Class 3 Permit Modification Request

Addition of a Concrete Overpack Container Storage Unit

Waste Isolation Pilot Plant
Carlsbad, New Mexico

WIPP Permit Number - NM4890139088-TSDF

Figure A1-38
Concrete Overpack Container Storage Unit

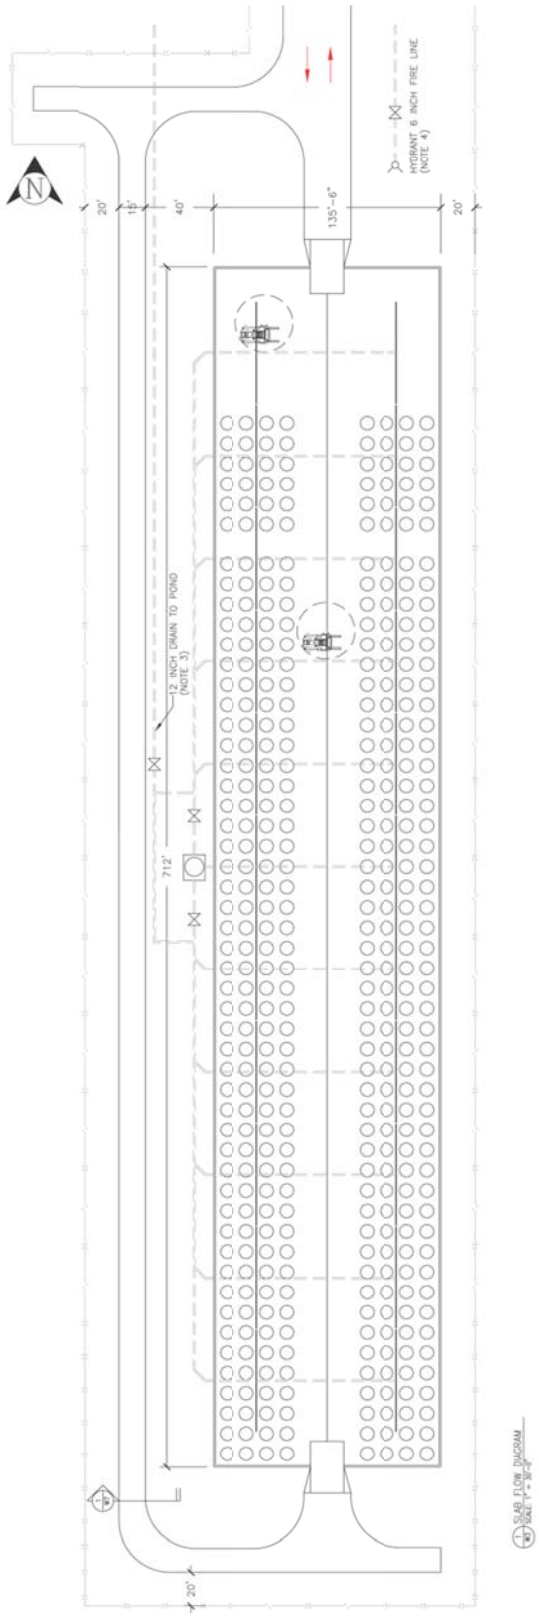
- Revise Attachment A1, Container Storage, Figures to add two figure drawings: A1-38 for the concrete overpack unit area and A1-39 for the concrete overpack container)

The area south of the rail siding (see Figure A1-38) will be used for storage of TRU mixed waste containers within concrete overpacks. The Overpack Unit provides storage space for up to 65,280 ft^3 (1,836 m^3) of TRU mixed waste, contained in up to 408 loaded engineered concrete overpacks. Secondary containment and protection of the waste containers from standing liquid are provided by the concrete overpacks. Concrete overpacks placed in the Overpack Unit will remain closed while in this area. The maximum residence time for waste stored in concrete overpacks is 365 days from the date TRU mixed waste containers were placed into the concrete overpack.

Figure A2-12
WIPP Facility Surface and Underground CH Transuranic Mixed Waste Process Flow Diagram

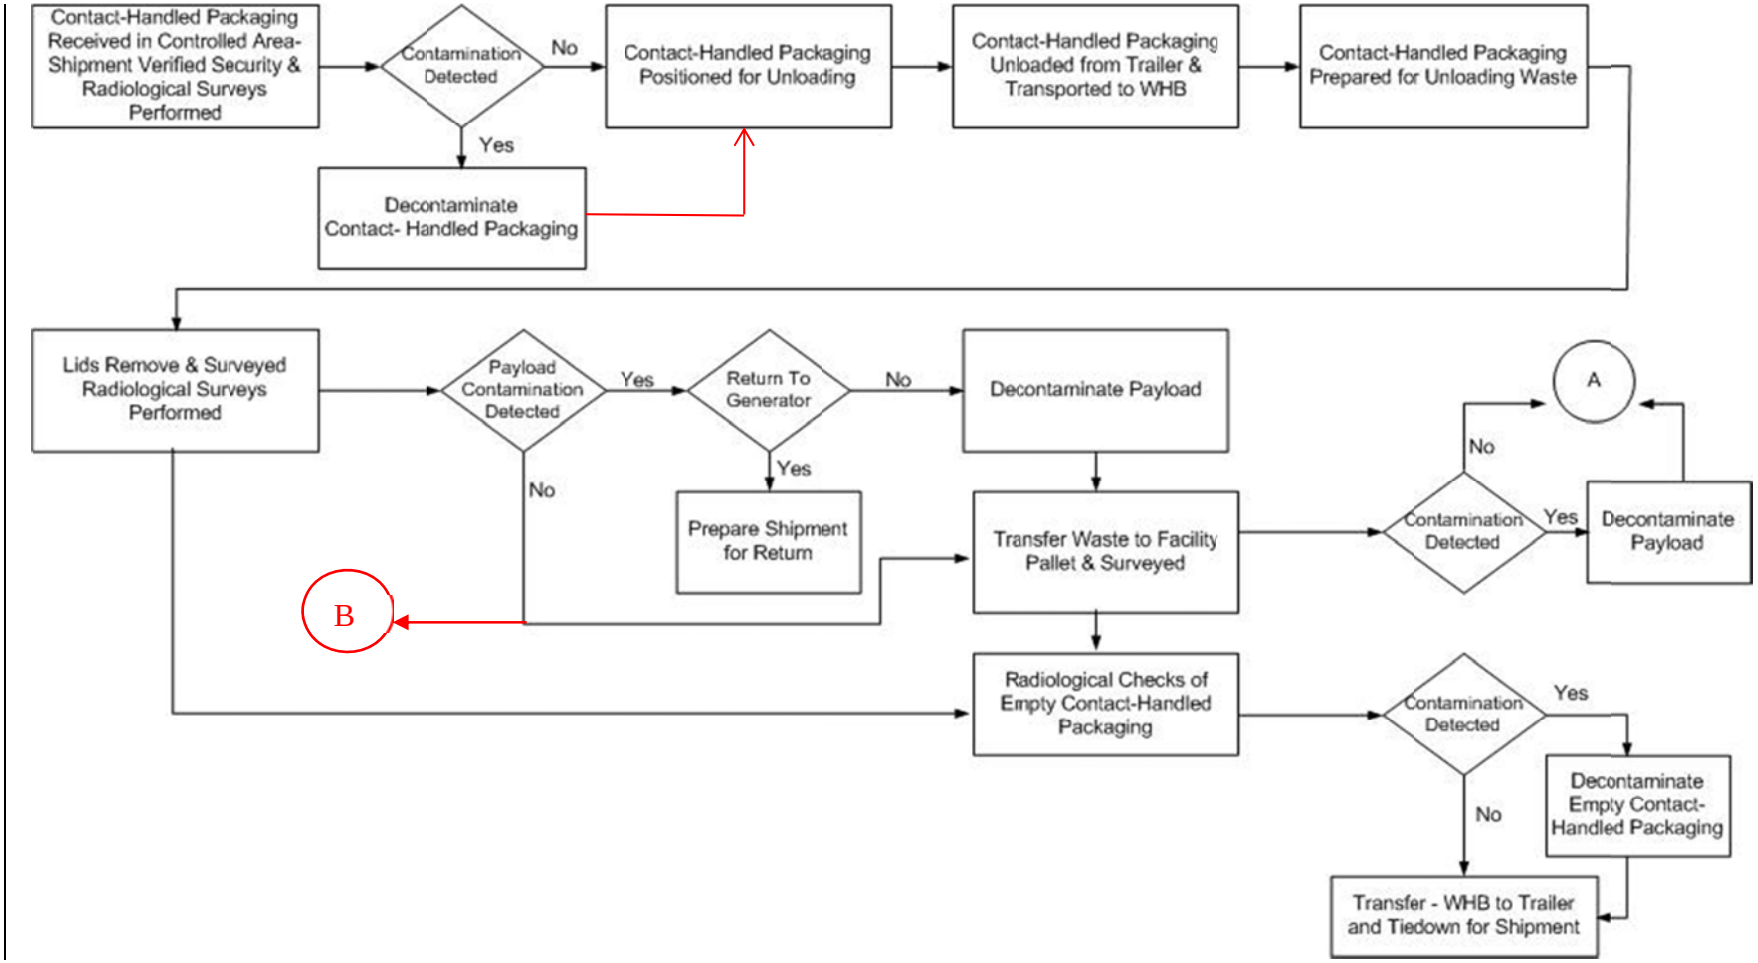
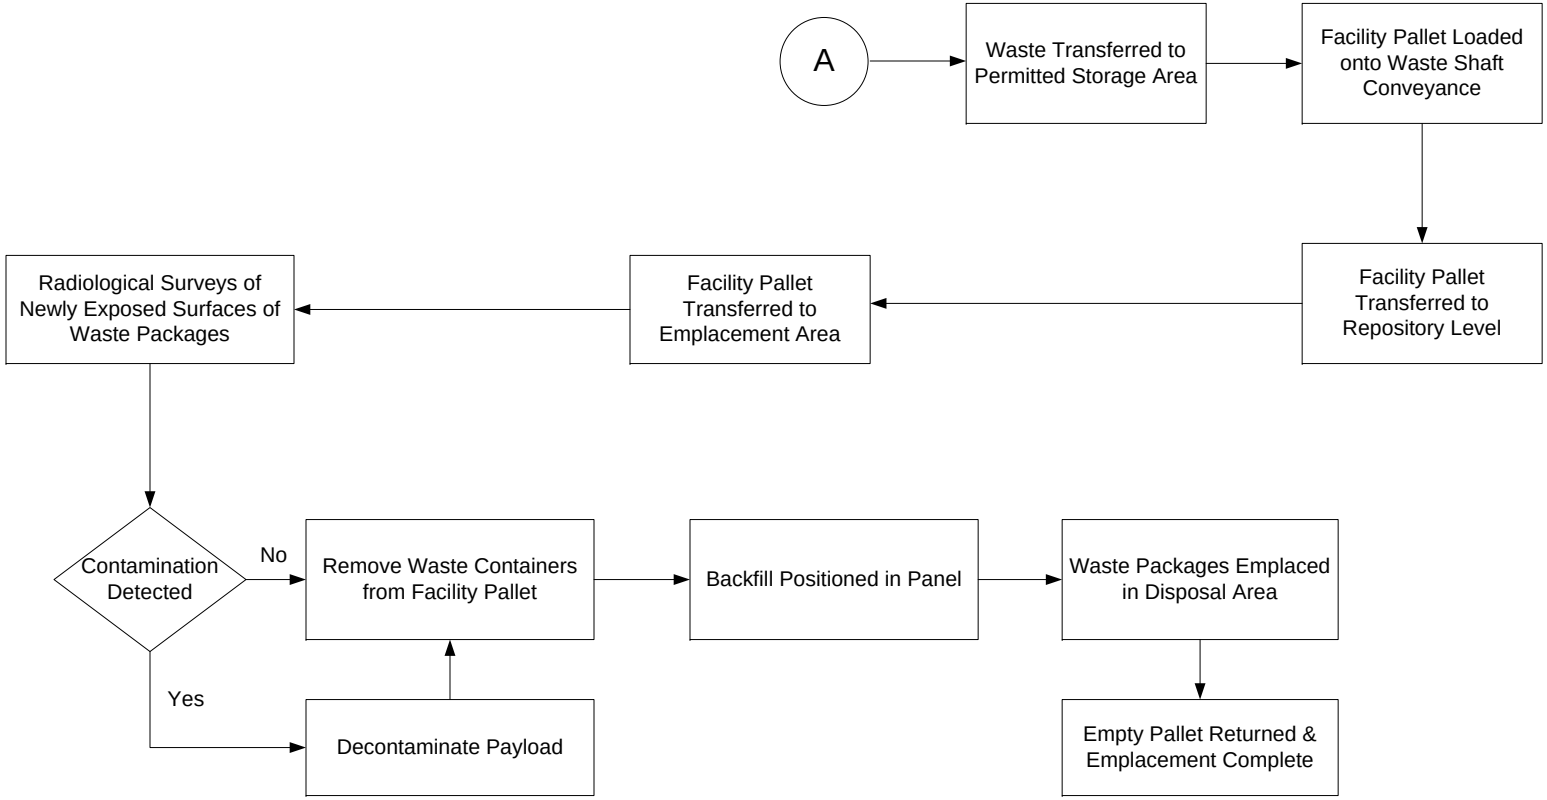
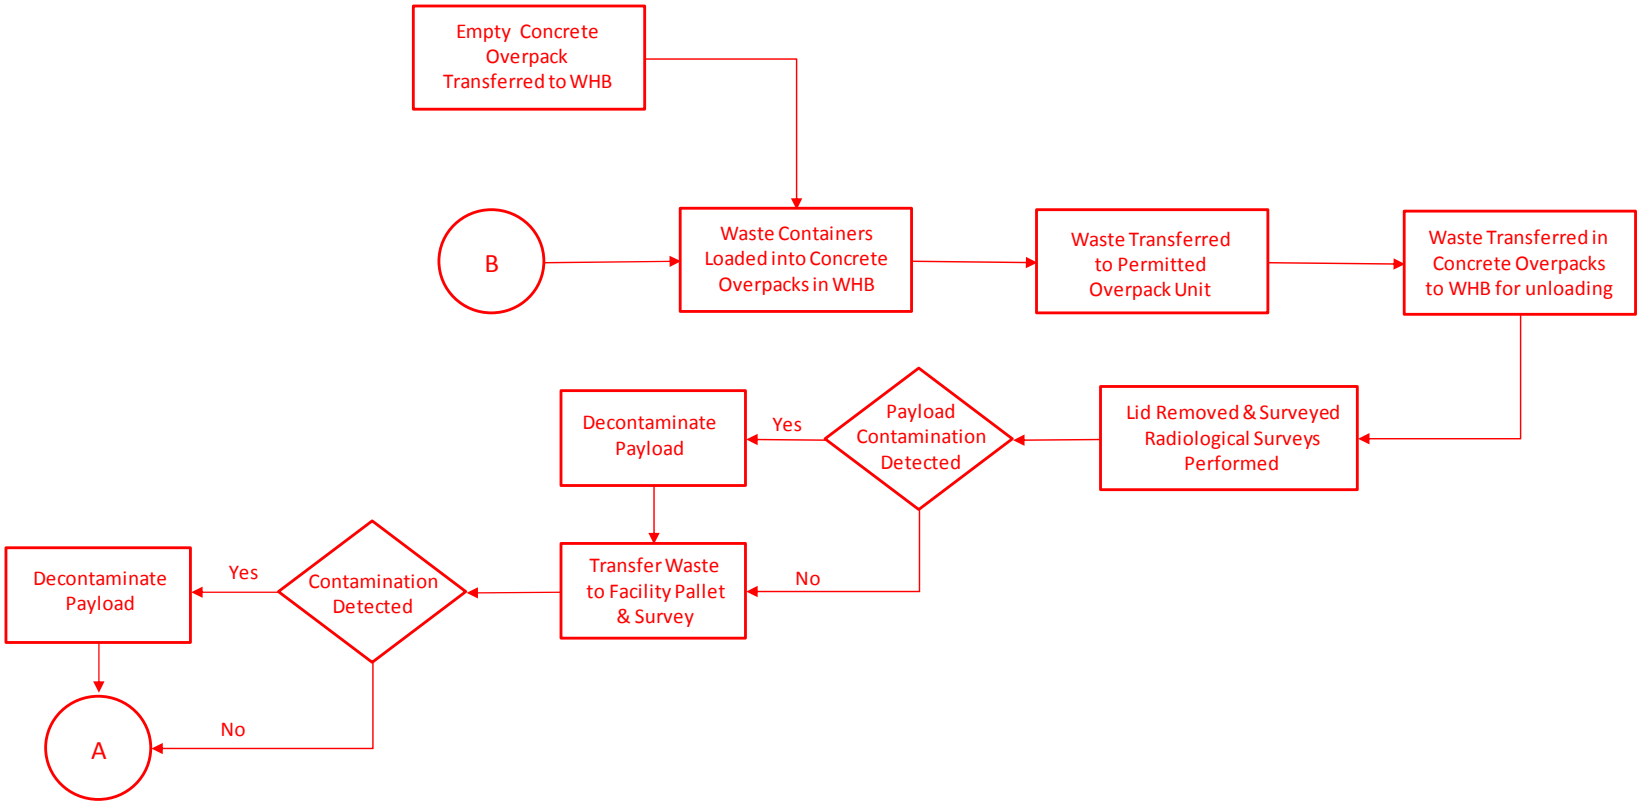
- Revise Attachment A2, Geologic Repository, Figure A2-12, WIPP Facility Surface and Underground CH Transuranic Mixed Waste Process Flow Diagram

Attachment A2, Table A2-1	Added row with "Concrete overpack forklift" in first column and "46,100 lbs." in second column. Added row with "Concrete overpack with lid" in first column and "46,100 lbs." in second column. Added row with "Concrete overpack with lid" in first column and "32,100 lbs." in second column.	B-22
Attachment A2, Figure A2-12	Updated both pages of this figure to show the updated process for mixed waste.	B-23

Figure A4-8
Waste Transport Routes in WHB – Concrete Overpack Loading and Unloading

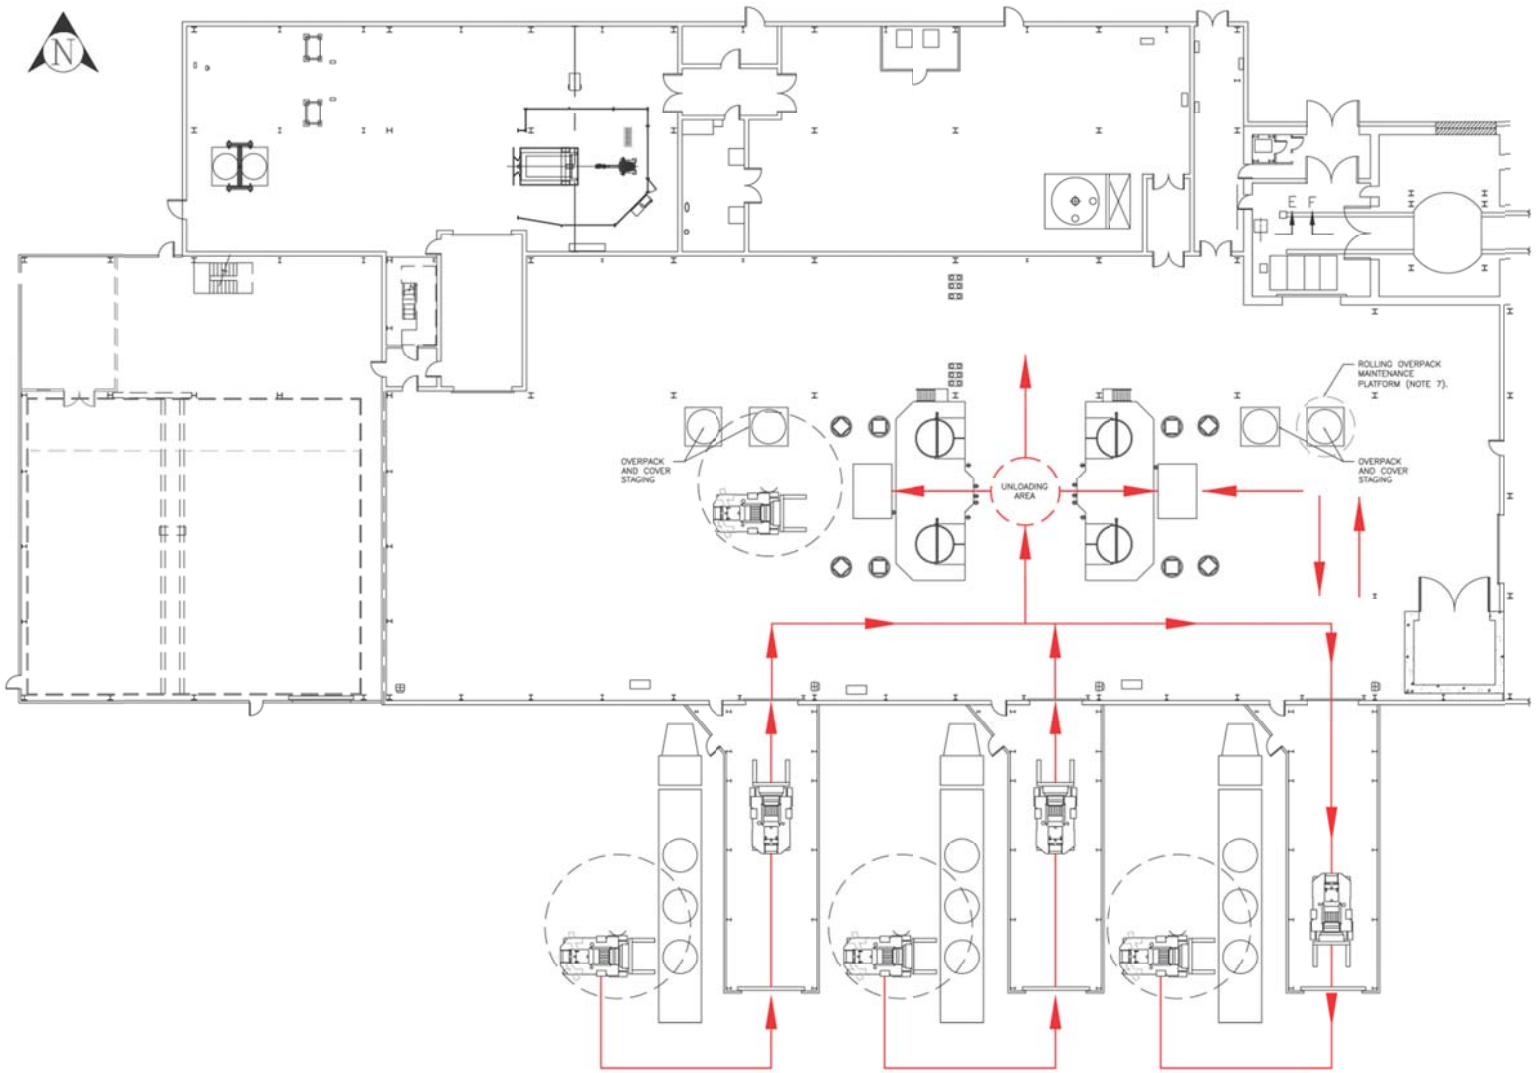
- Revise Attachment A4, Traffic Patterns, Figures add two new figures, Figure A4-8 and Figure A4-9 to show traffic patterns for the new concrete overpack container storage unit)

Figure B2-2
Planimetric Map - WIPP Facility Boundaries

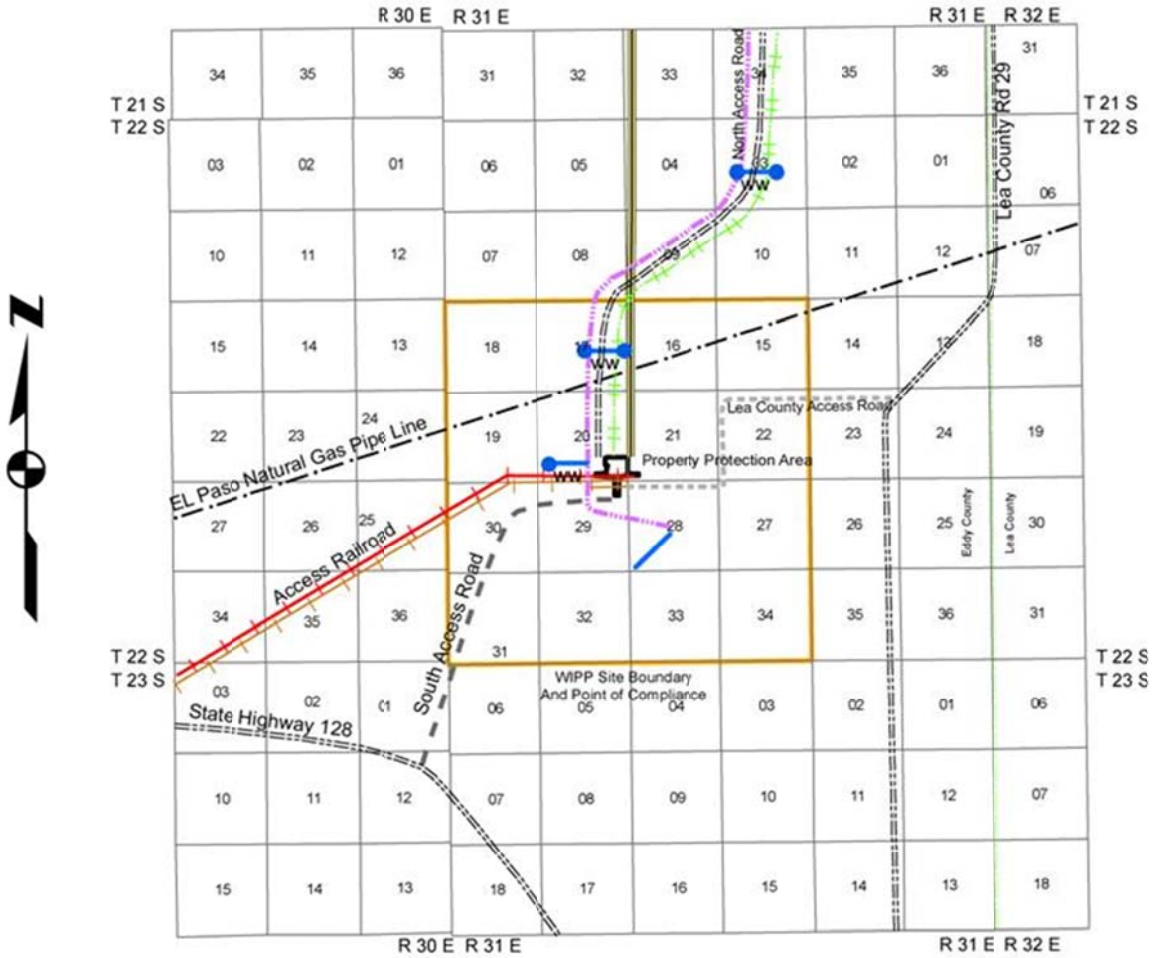
- Revise Attachment B, Hazardous Waste Permit Application Part A, Appendix B2 Maps to replace Figure B2-2 with a more legible figure and Figure B2-2a Note 1 is being revised to change the Property Protection Area (**PPA**) from approximately 35 acres to approximately 40 acres.

- Figure B2-2 is being replaced with a more legible figure and Note 1 is being revised to change the PPA from approximately 35 acres to approximately 40 acres

Figure B3-5
Concrete Overpack Container Storage Unit

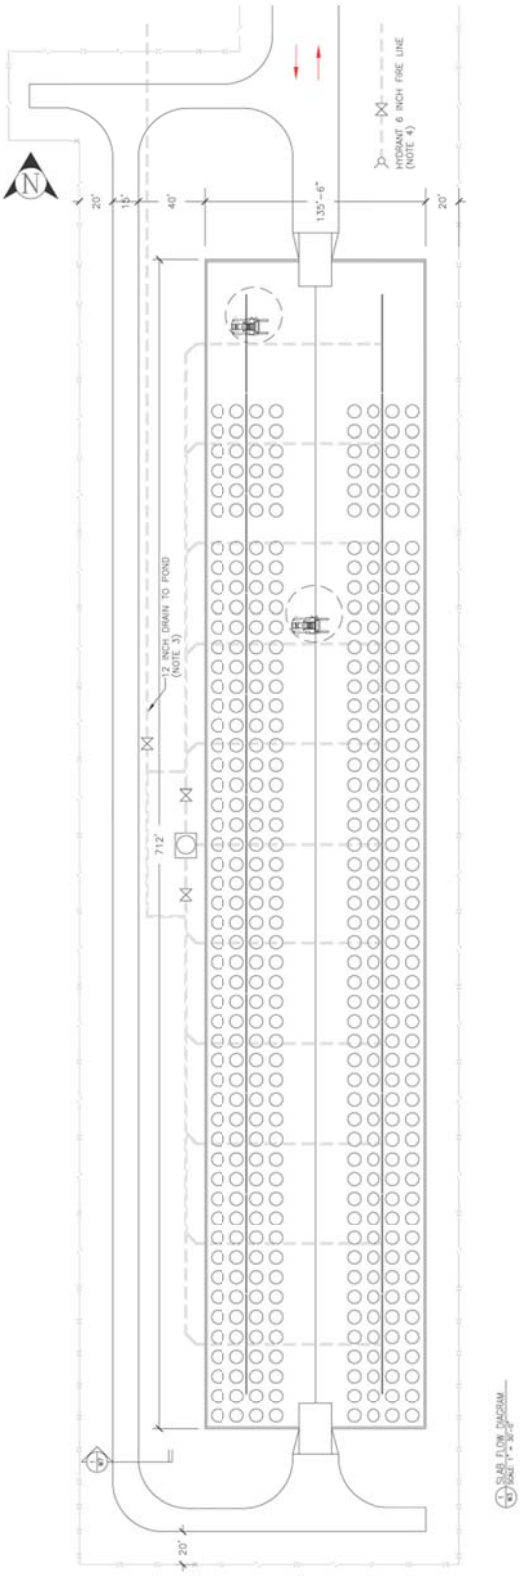
- Revise Attachment B, Hazardous Waste Permit Application Part A, Appendix B3 Facilities to add Figure B3-5 to show the Concrete Overpack Container Storage Unit

- New Figure B3-5 is being added to depict the Concrete Overpack Container Storage Unit
